Applicant : HU, Yongjun Jeff
Appl. No. : 10/659,728
Filed : September 10, 2003
For : METAL GATE ENGINEERING FOR
SURFACE P-CHANNEL DEVICES
Examiner : NHU, David
Art Unit : 2818

AMENDMENT

METAL GATE ENGINEERING FOR SURFACE P-CHANNEL DEVICES

PROPOSED REPLACEMENT SHEET

FIG. 2

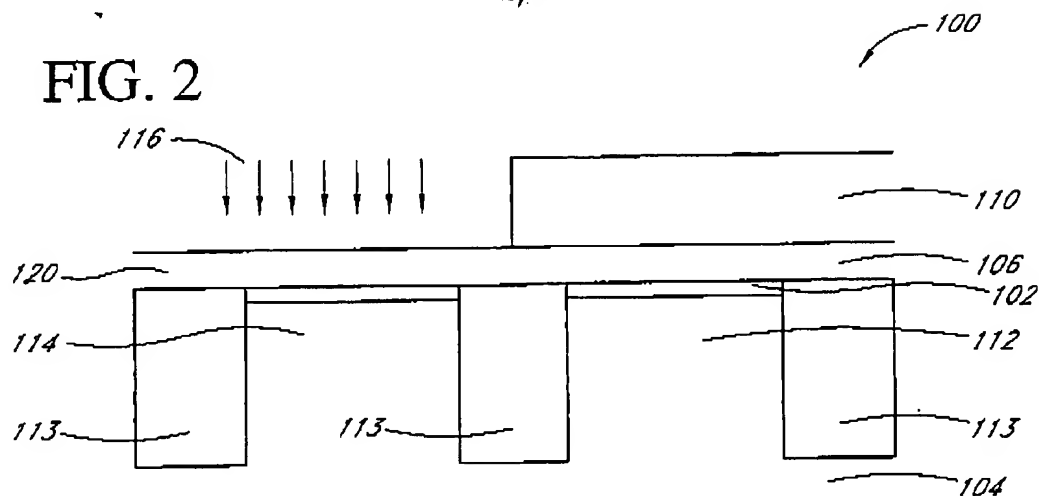
The attached "Proposed Replacement Sheet" includes proposed amendments to Figures 2 and 4. These proposed amendments are being made in response to the objections to the drawings by the Examiner in the Office Action. No new matter is being entered herewith.
